Department of Energy
Albuquerque Operations Office
P.O. Box 5400
Albuquerque, New Mexico 87185-5400

May 5, 1997

Enclosed are four copies of the final page changes (numbered Attachment 1 through 12) for incorporation into the preliminary final Clive Completion Report, dated March 1996. All of the changes made to the Completion Report, except for the changes discussed in items 9 and 10 below, were necessary to document the corrective action repairs that were recently completed. Corrective action repairs were required because some of the erosion protection material in various areas on the disposal cell did not meet the design intent (see Appendix K of the Completion Report).

**SOUTH CLIVE SITE
URANIUM MILL TAILINGS REMEDIAL ACTION
COMPLETION REPORT**

EXHIBIT 4

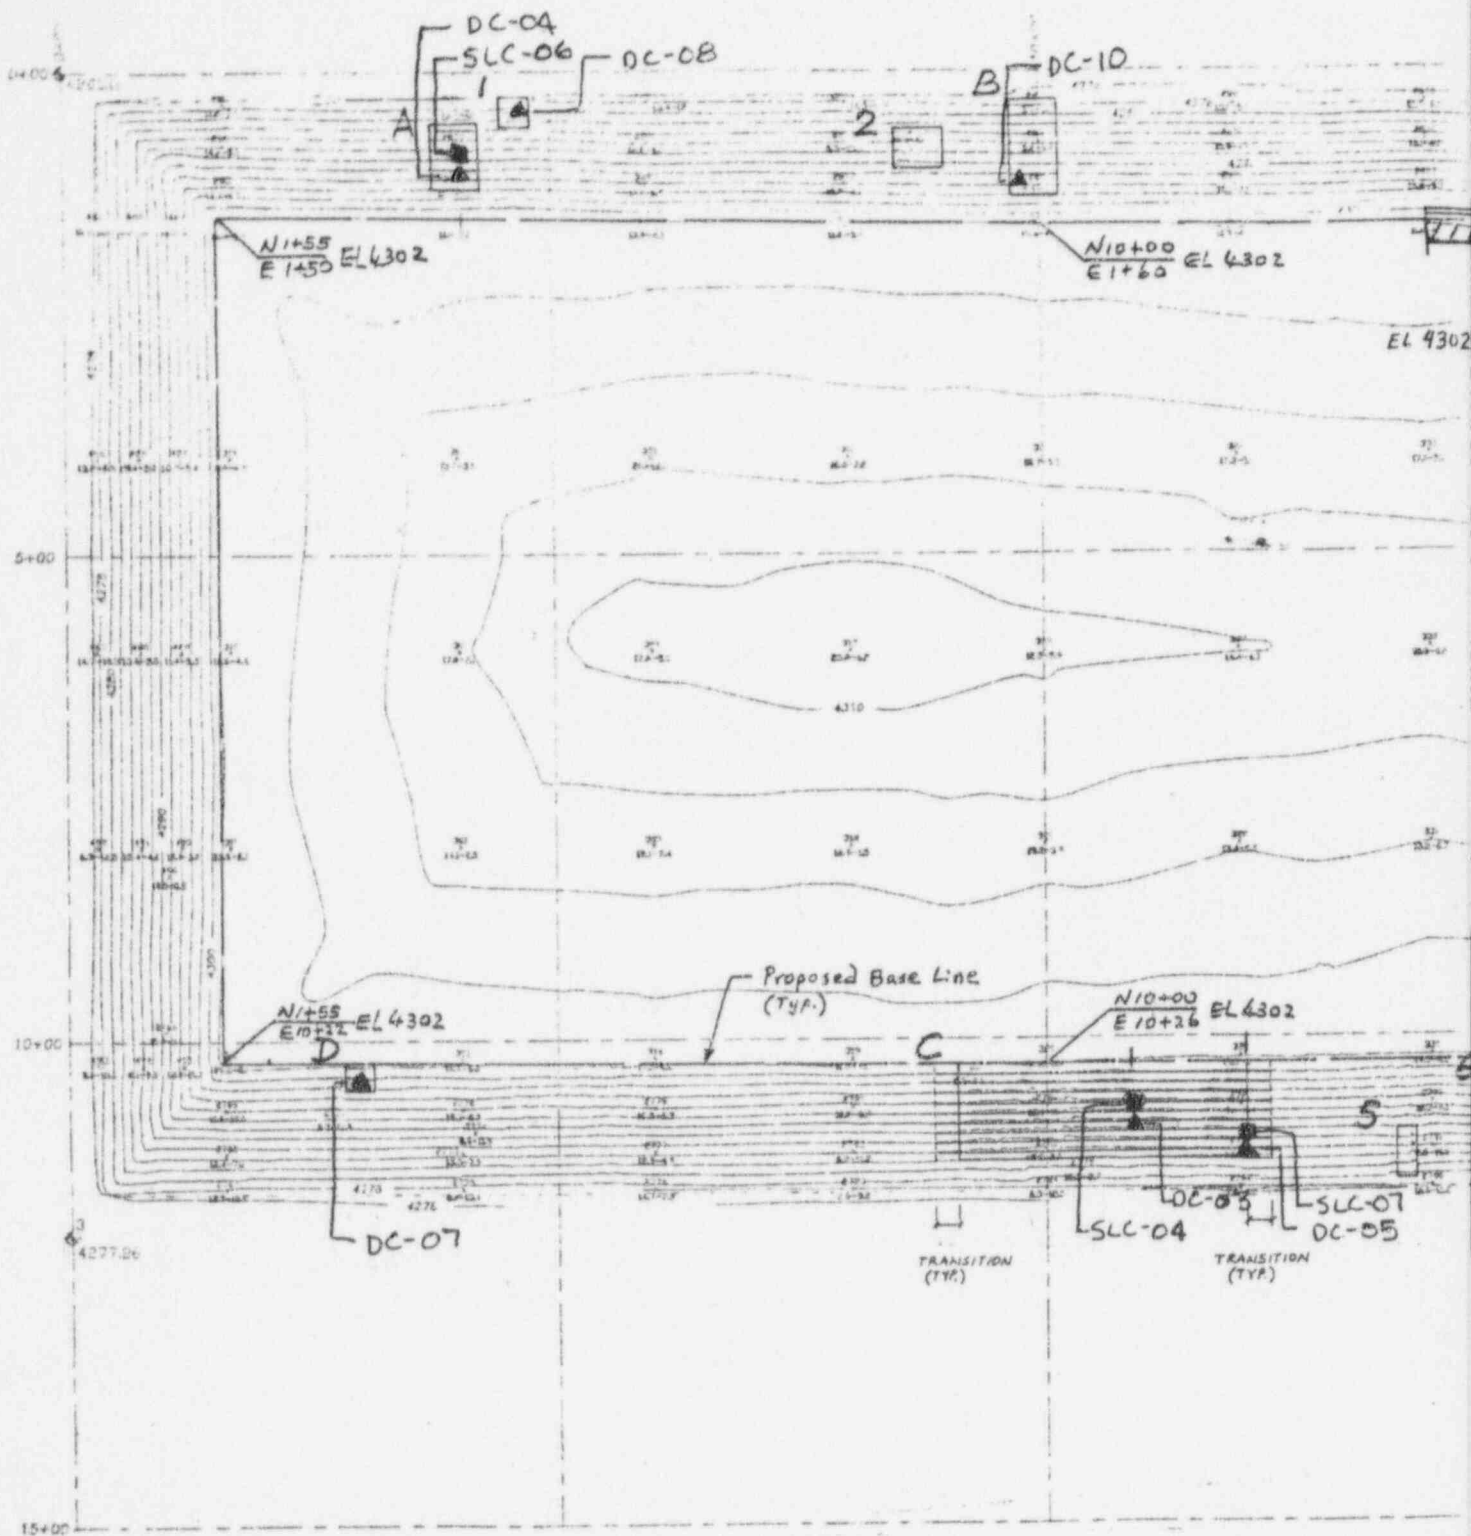
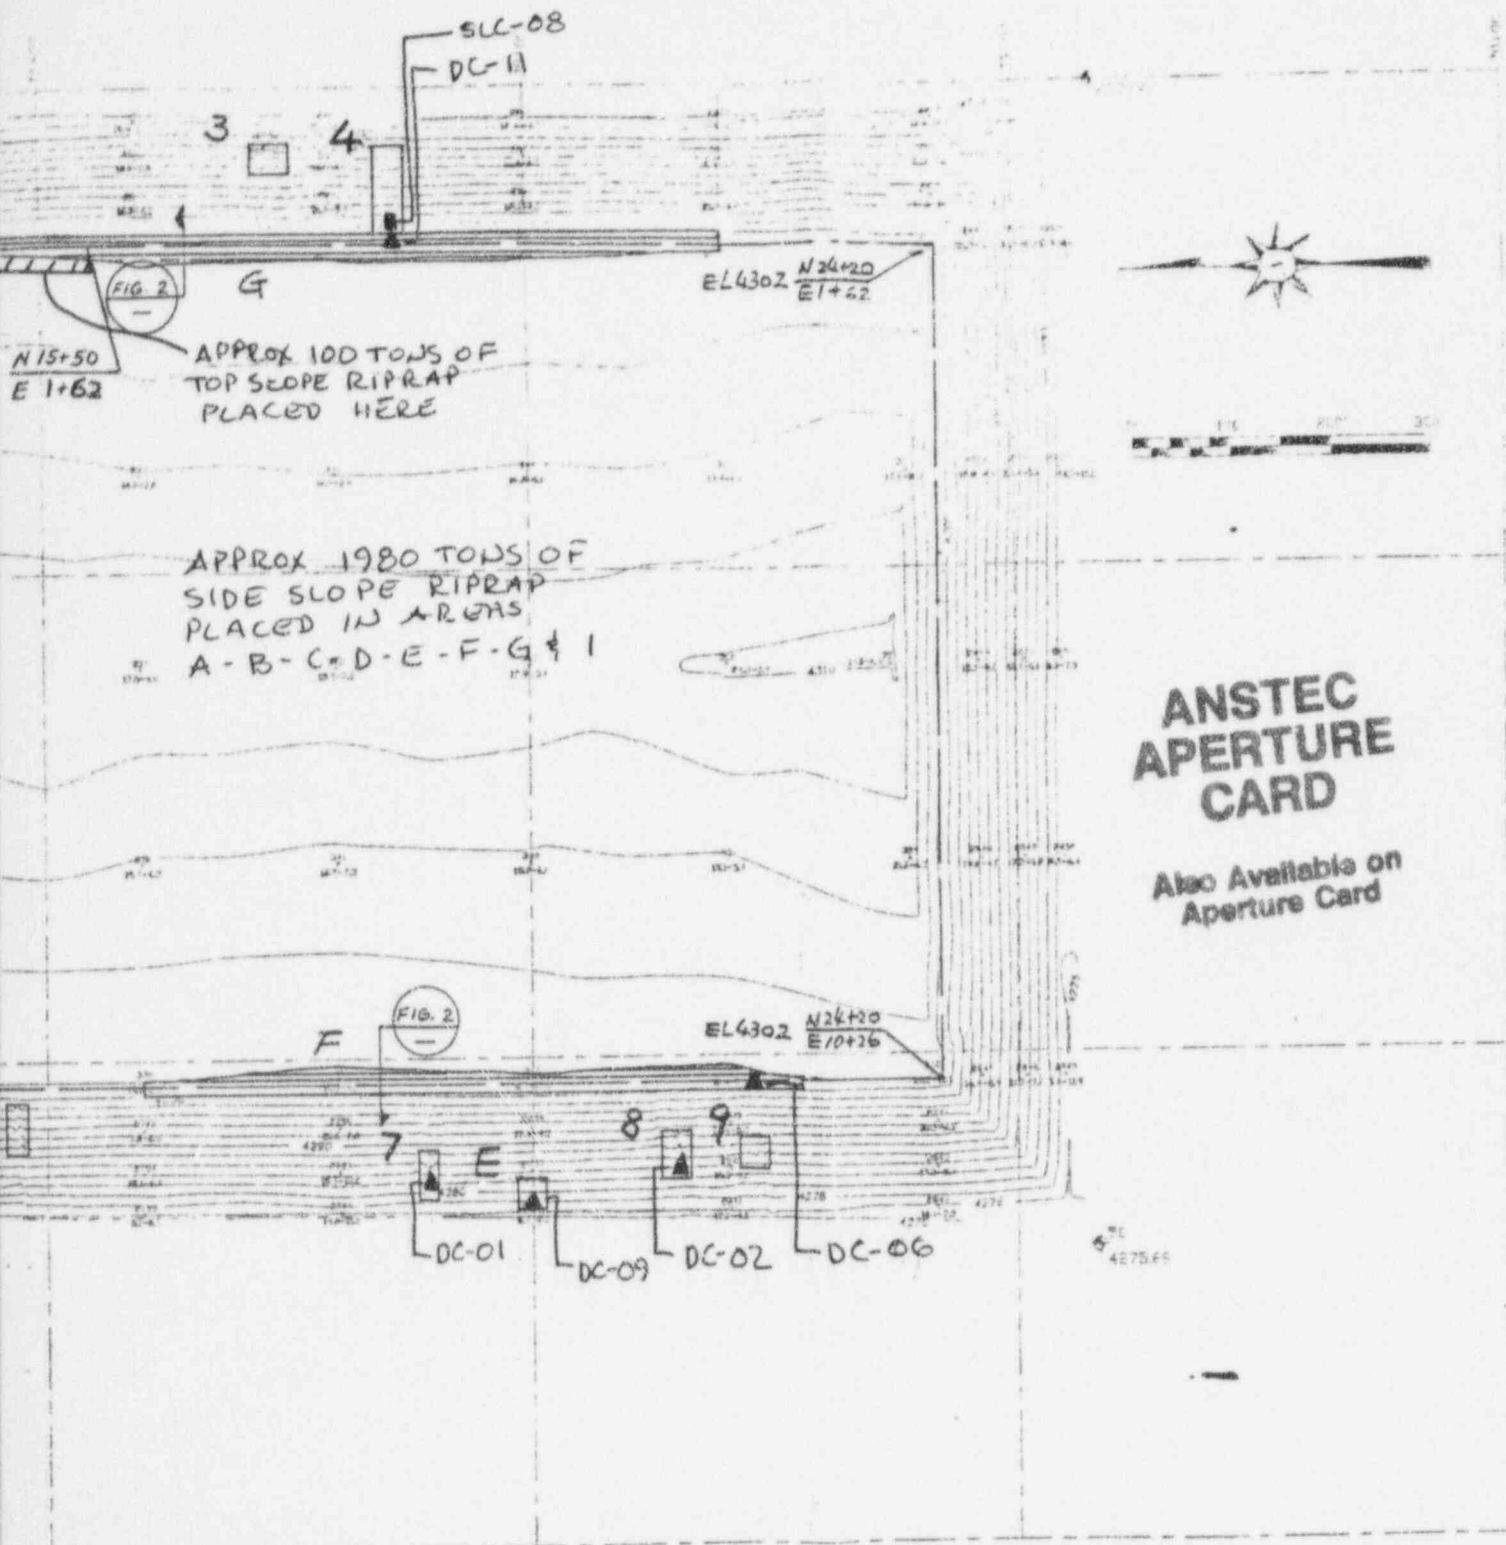
Exhibit 4 shows the detailed locations where riprap repair and in-place testing was performed.

In Exhibit 4, the as-built drawing depicts the various repair or re-graded areas. These are designated Areas A through I, and are the locations in which depth checks and gradations were performed. All of the disposal cell repair work was performed in accordance with recommendations and technical requirements in the Engineering Assessment (Appendix K).

1. Surface irregularities on the east and west sideslopes were re-graded. Re-grading resulted in a uniform surface which eliminated the concern for flow concentrations.

2. Small areas on the cell of segregated fine particle size riprap material were removed, and were replaced with new riprap material meeting technical design requirements for quality, particle size, and layer thickness.

3. Additional sideslope riprap material was produced, and added to areas where layer thickness did not meet the minimum thickness requirement. The additional material was worked into the existing riprap layer to provide a uniform well graded surface with adequate layer thickness.

4. The southeast and southwest corners of the disposal cell topslope were re-graded to reduce excessively steep grades, and to provide a more uniform grade break. First, the sideslope was adjusted by adding new material to extend the 5(H):1(V) sideslope. Following completion of the sideslope adjustment, the topslope riprap was re-graded. Re-grading of these topslope areas provides a more uniform grade break.
